# **Report on ad hoc calls on terminology around DWDM**

IEEE P802.3ct Task Force, Interim Teleconference Call, 18 February 2021

Figure 154–3—DWDM black link example configuration for specifying  $n$  DWDM channels

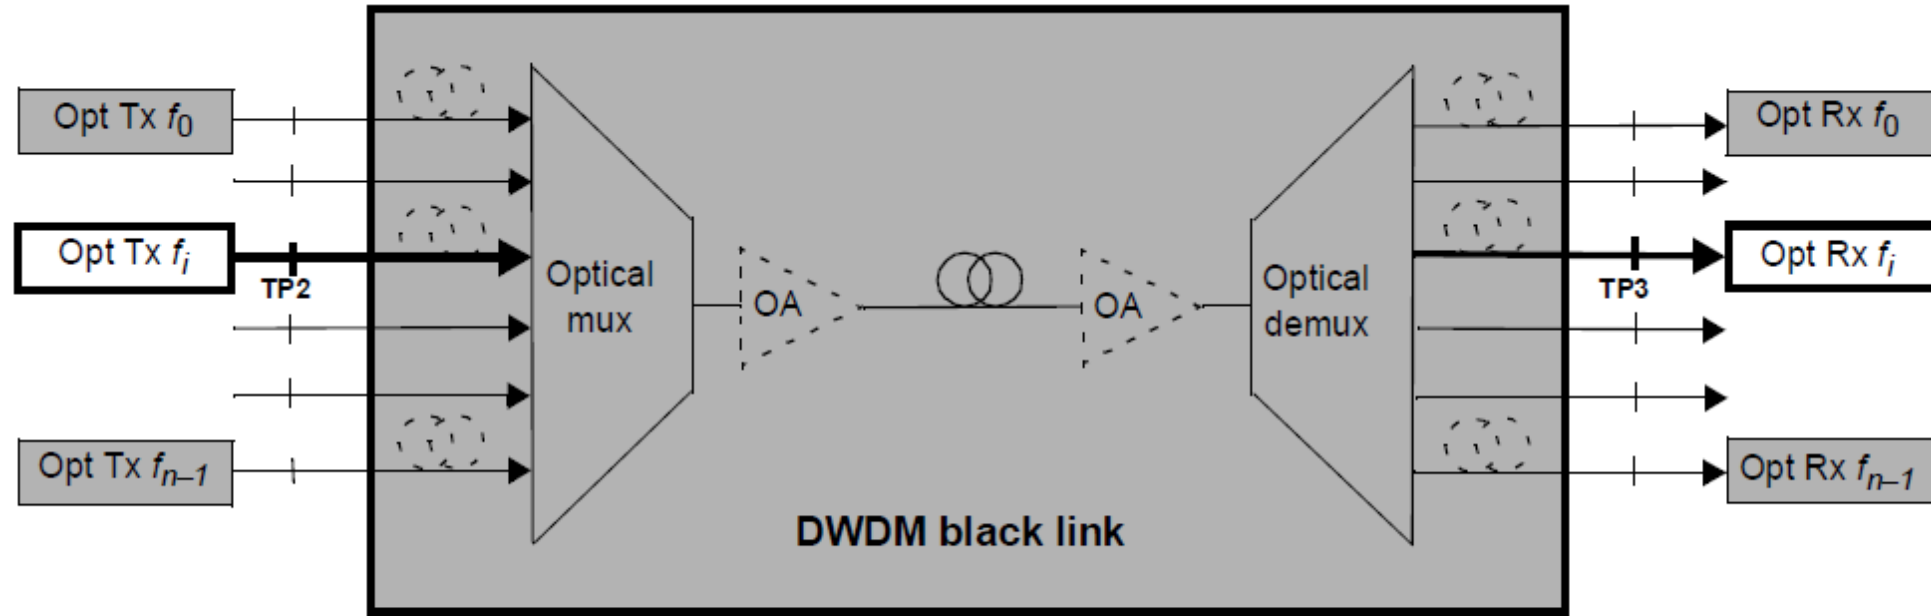
# Result of ad hoc discussions on Figure 154-3

It was the consensus of the ad hoc to modify Figure 154-3 to:

For clarity, only one direction of transmission is shown

- The consensus of the ad hoc to modify Figure 154-3 as shown on slide 6 of this presentation was not unanimous.
- One participant strongly preferred variant 2 shown on slide 4 of [stassar\\_3ct\\_02\\_210216](#), where the variant of Figure 154-3 does not show any details inside the “grey box” called DWDM black link.
- In addition to the consensus view on Figure 154-3, the group felt that further discussion would be needed to develop new material for inclusion in Annex 154A, for instance by adding further variants of Figure 154-3, e.g. one showing bi-directional transmission.
